Staff Report to the Zoning Administrator

Application Number: **05-0173**

Project Description: Proposal to construct a four unit dwelling group of two, 3-story, detached dwelling units, two 2-story detached units and a fence (trash enclosure) exceeding 3 feet high in the front yard setback and to extend Lot Line Adjustment Permit 04-0268 for an additional one year time period.

Location: The project is located on the south side of West Walnut Street about 200 feet west of the intersection of West Walnut Street and Daubenbiss Avenue, Soquel (440 W. Walnut).

TREE LOCATION & PROTECTION PLAN 4440 WEST WALNUT

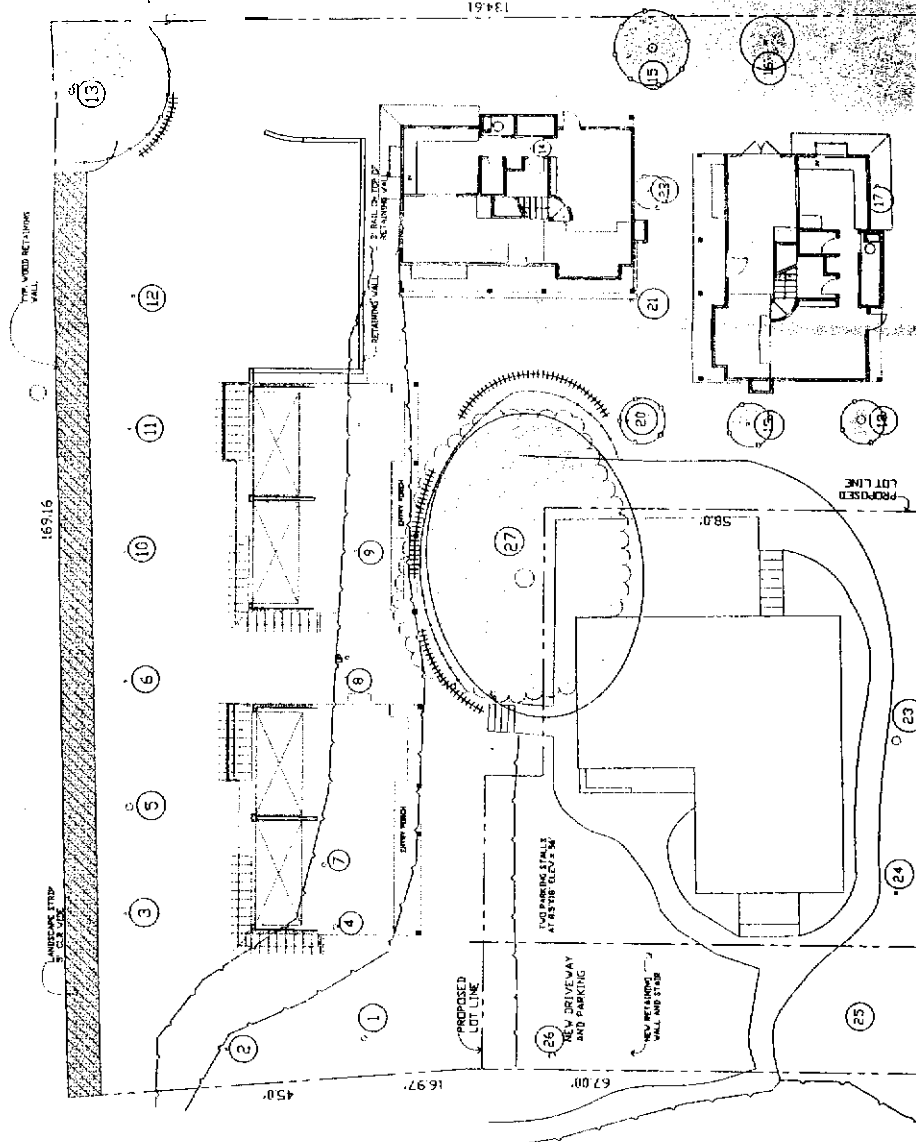
- 2) On the Grading Plan, show tree protection measures recommended by the arborist for trees to be retained. The plan should correspond with the Tree Location and Protection Plan included in the arborist's report. The arborist suggests tree protection fencing and sometimes straw bales as tree protection measures.

This application proposes to remove 16 trees and an arborist's tree analysis and upgraded landscape plan have been submitted. The tree location map indicates protective fencing in red around several trees to be retained. However, the fencing does not match the green circles for tree locations of #15, #16, #18 and #19 trees. All or part of these trees are shown outside the protective fencing on this map. Will this be corrected as necessary?
